ADDENDUM NUMBER 5

**PROJECT: A NEW ADDITION TO DEKALB COUNTY JAIL
FOR THE DEKALB COUNTY COMMISSION
FORT PAYNE, ALABAMA
GMC PROJECT NO. ABHM190069
Local Funds**

**Re: Dekalb County Jail
Redesign for Single Story
Dekalb County, Alabama
JRA Project No. 222144**

E1.01
 sheet of

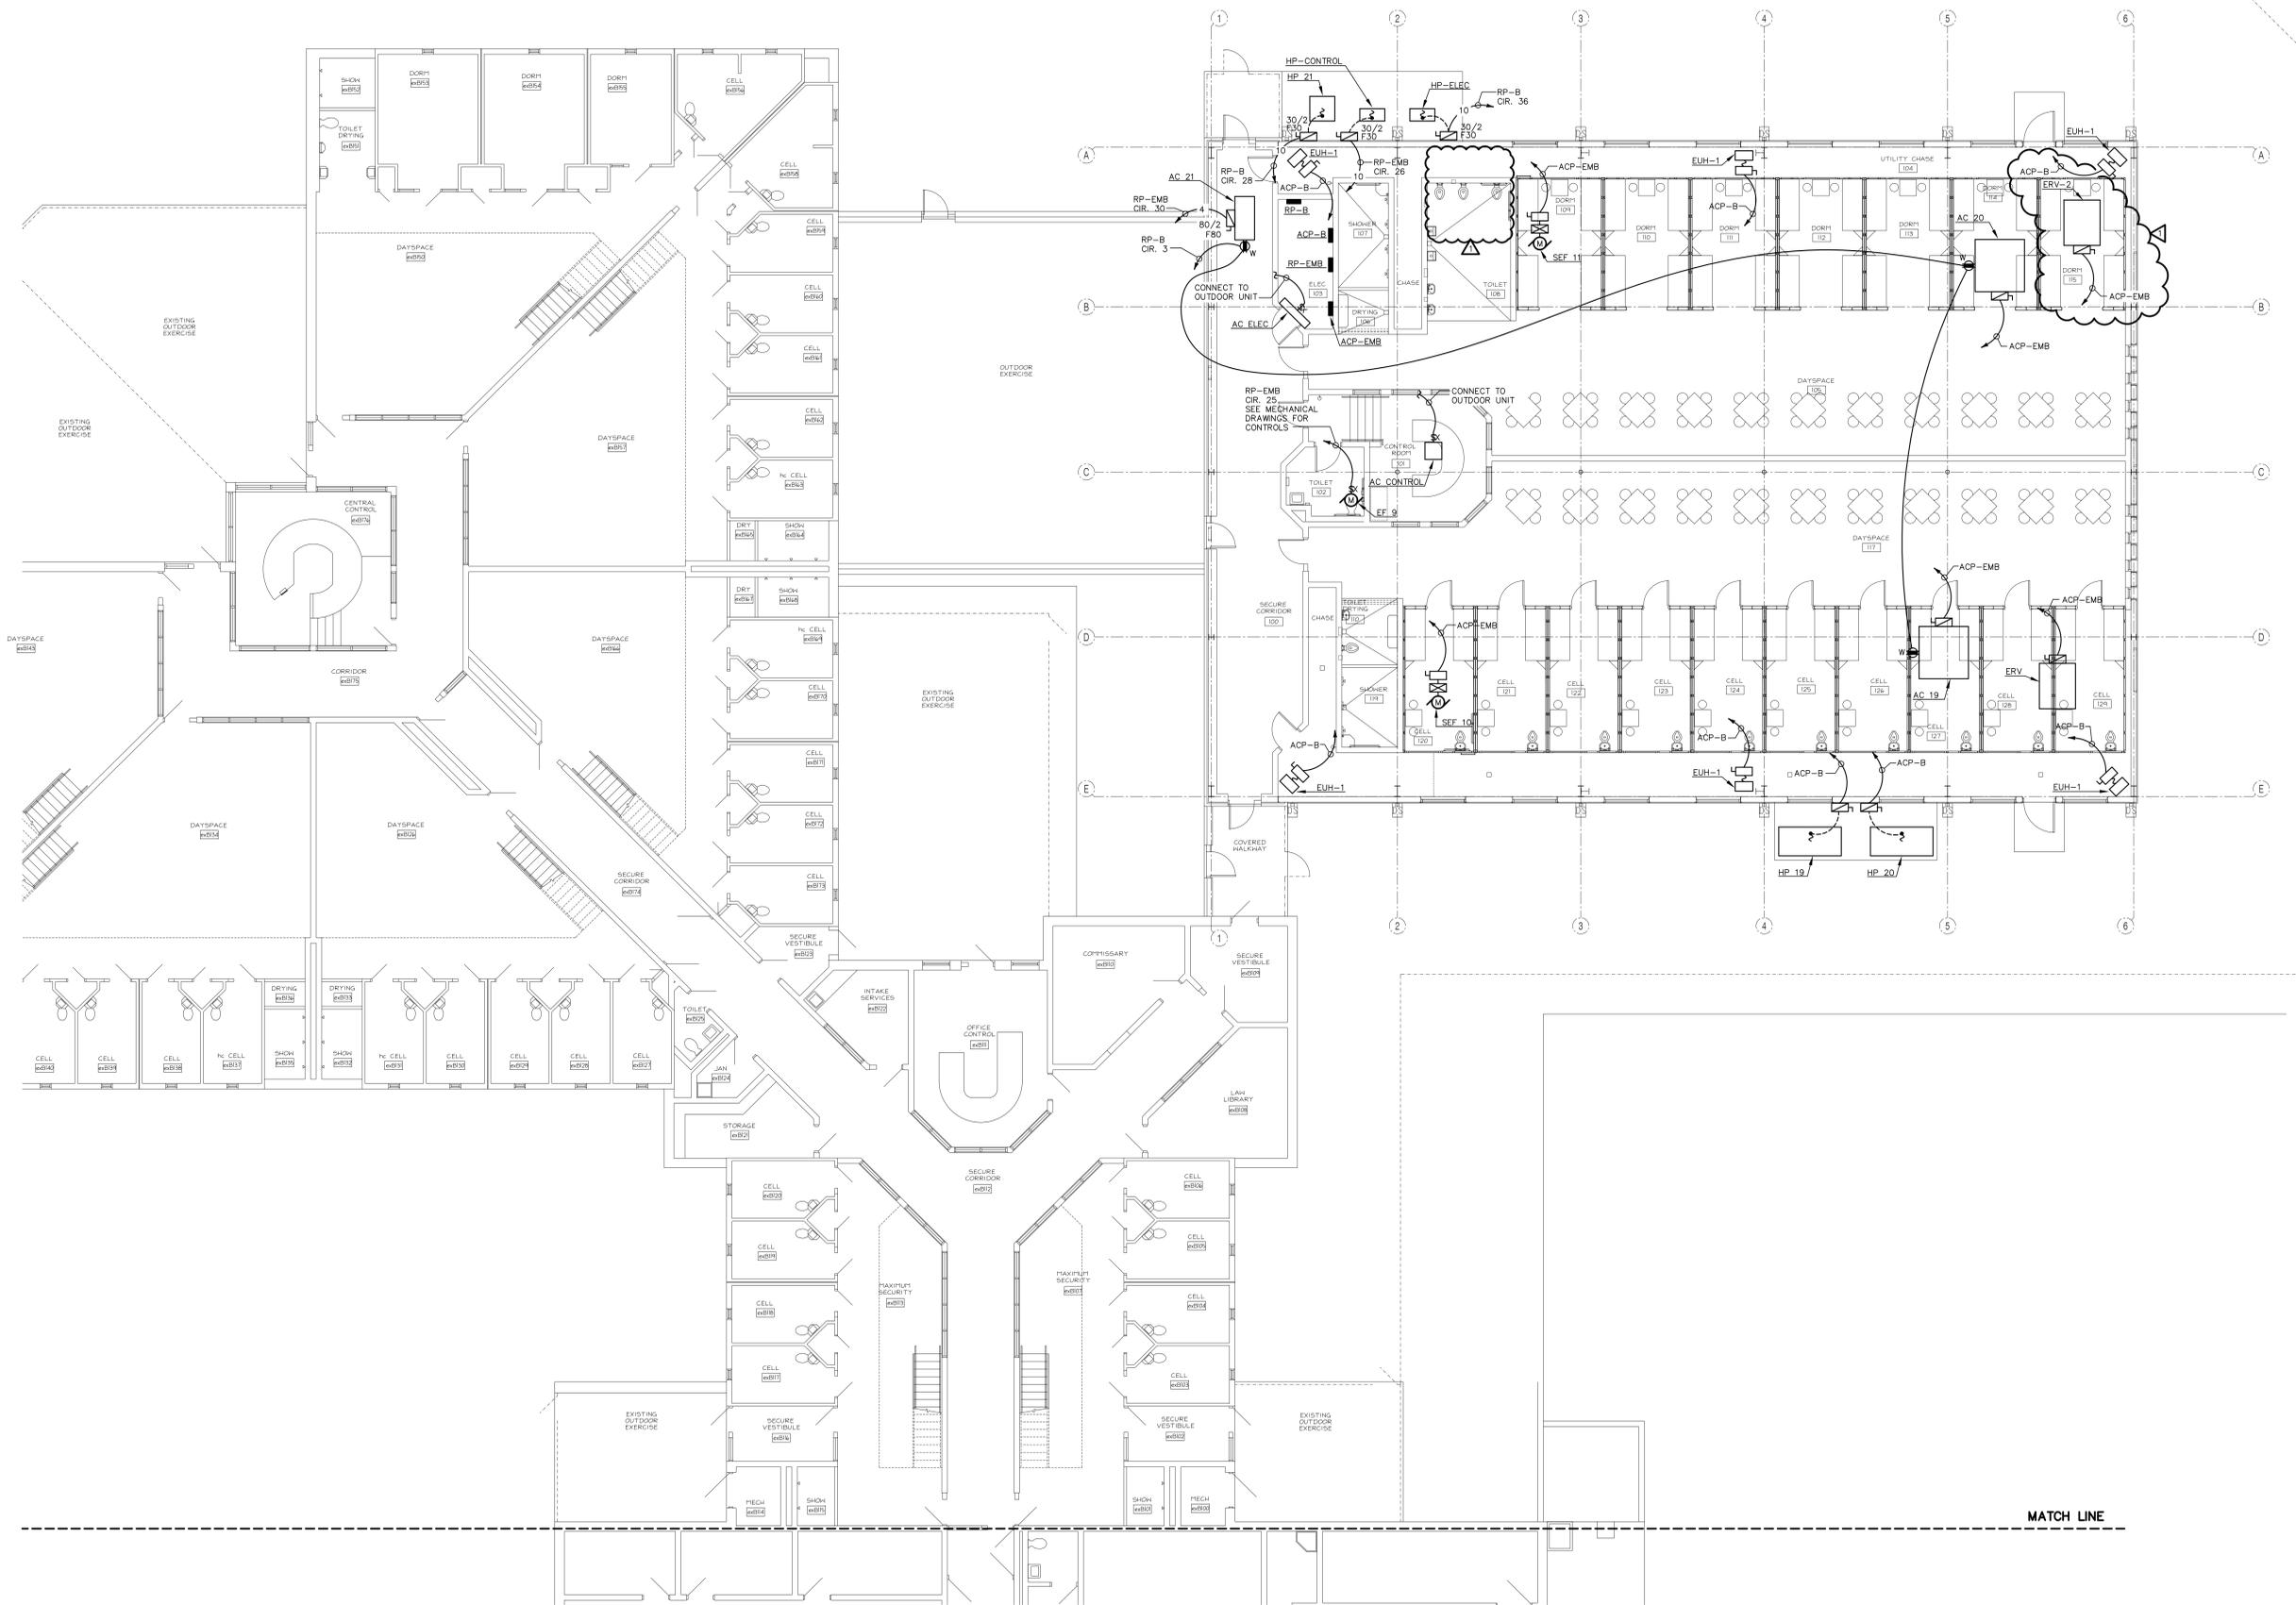
2. Sheet E1.01:
 - (A) Floor plan indicates RP-EMB circuit 10 controlled through LC-B, but circuit is not listed in Relay Panel LC-B Schedule.
Response: The circuit on E1.01 should be circuit 2, RP-EMB.

4. Sheet E5.01:
 - (A) RP-EMB circuit 2 listed in Relay Panel LC-B Schedule, but not shown on floor plans.
Response: We have revised the lighting plan to show circuit 2 is the circuit feeding the cell lights on the north side of the plan.

M1.0
 sheet of

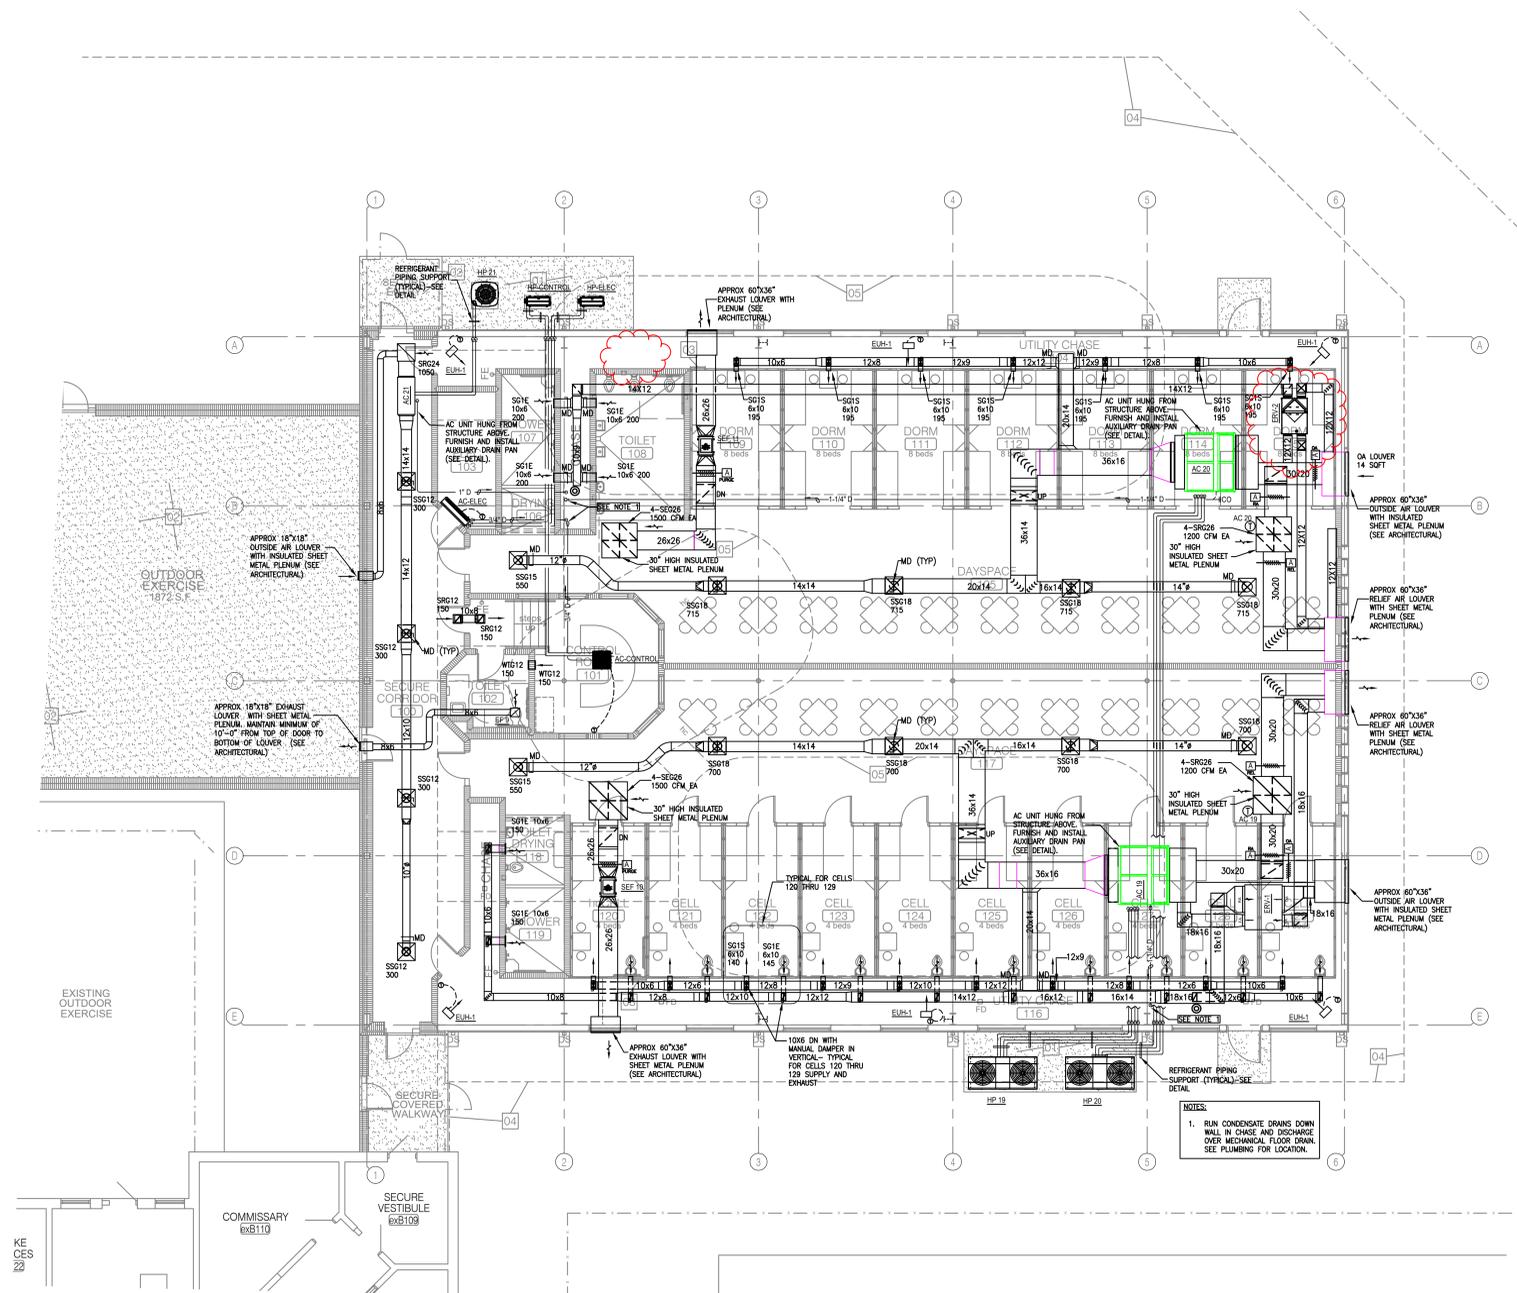
1. Refer to the attached Letter from the Electrical Engineer to the Department of Construction Management in response to their final review letter. The responses from the engineer shall be added to this project in full force as part of the construction documents.
2. The attached drawings: E1.01, E2.02, E3.01, E4.01, E5.01, shall be added as revised versions of these sheets. See Section AD5-2 Project manual and specifications above for addition information.
3. Refer to the attached drawings pdf drawings ERV-2 schedule (M0.01) and ERV-2 Plan (M1.0). See clouded areas for additional information.
